# Access Compliance Report

## Public Rights-of-Way

### (Curb Ramps)

Intersection ID: 7456	Main Street: PONDELLA_DR	Cross Street: ROSADA_AV	Location:	N
ADA ID: E83FF0C4296E	Ramp Type: Para	Initial Pass/Fail: Fail	Overall Compliance: No	Severity Score: 12.5
Codes/Mitigation Info/Possible Solution		Field Measurements/Component Compliance

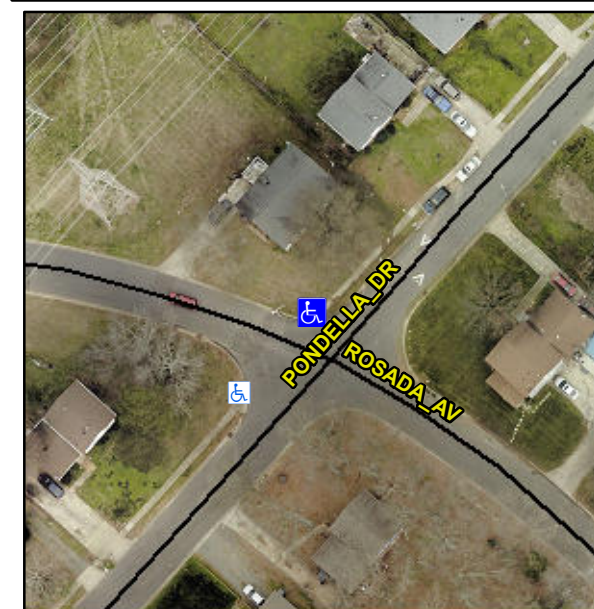
**CURB GAP 1.0, NO LT SW, RT RP < 5%**

**R304.5.3**

Compliance	Description	Data	Compliance	Description	Data
N/A	Ramp Length LT (in)	63.0	N/A	Ramp Length RT (in)	43.5
Yes	Ramp Width LT (in)	48.5	Yes	Ramp Width RT (in)	51.5
Yes	Ramp Slope LT (%)	5.5	Yes	Ramp Slope RT (%)	1.9
No	Ramp XSlope LT (%)	2.8	No	Ramp XSlope RT (%)	5.1
N/A	Landing Length (in)	N/A	N/A	DWS Provided?	N/A
N/A	Landing Width (in)	N/A	N/A	DWS Contrast?	N/A
N/A	Landing Slope (%)	N/A	N/A	DWS Length (in)	N/A
N/A	Landing X Slope (%)	N/A	N/A	DWS Full Width?	N/A
N/A	Landing Curb? (Y/N)	N/A	N/A	DWS Offset (in)	N/A
N/A	Shared Landing?	N/A			
N/A	Gutter Ponding?	N/A	N/A	Gutter Slope (%)	N/A
N/A	Gutter Lip Ht (in)	N/A	N/A	Gutter X Slope (%)	N/A
N/A	Painted X Walk1?	No	N/A	Painted X Walk2?	N/A
	X Walk 1 Direction	To SW		X Walk 2 Direction	N/A
N/A	X Walk 1 Width (in)	N/A	N/A	X Walk 2 Width (in)	N/A
	X Walk 1 Slope (%)	3.4		X Walk 2 Slope (%)	N/A
	X Walk 1 X Slope (%)	3.2		X Walk 2 X Slope (%)	N/A
N/A	Ramp inside XWalk1?	N/A	N/A	Ramp inside XWalk2?	N/A

**Remove & Replace Entire Ramp.**
